**PENINSULA TOWNSHIP
PLANNING COMMISSION
AGENDA
13235 Center Road
Traverse City, MI 49686
July 18, 2016
7:00 p.m.**

SPECIAL USE PERMIT
FINDINGS OF FACT
SUP #127, Vineyard Ridge (Planned Unit Development Condominium Subdivision)
July 18, 2016

Ken Schmidt
 Proposed PUD
 SITE PLAN
 Page 11 West
 County, Michigan
 Section 36, Town 28 N
 Peninsula Township, Grand

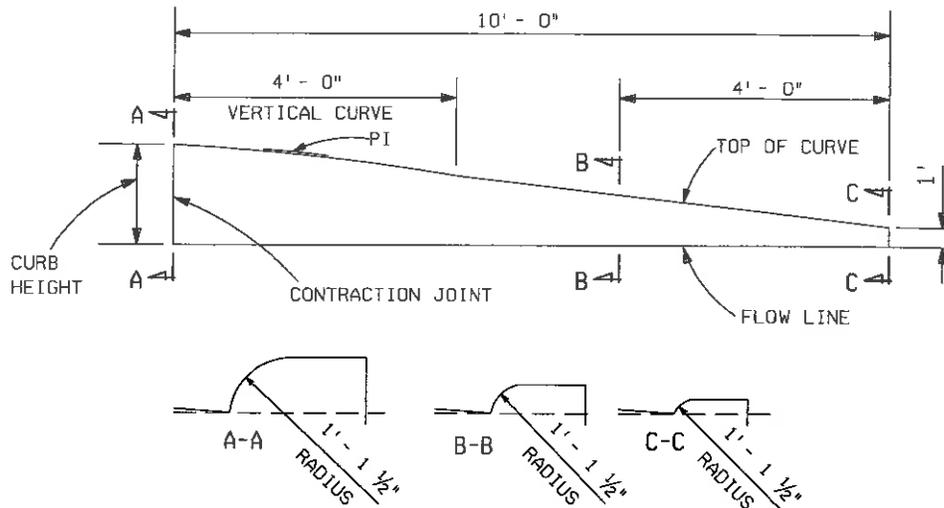
Is this our existing basin and structure?
 See old plans at the end of this PDF.
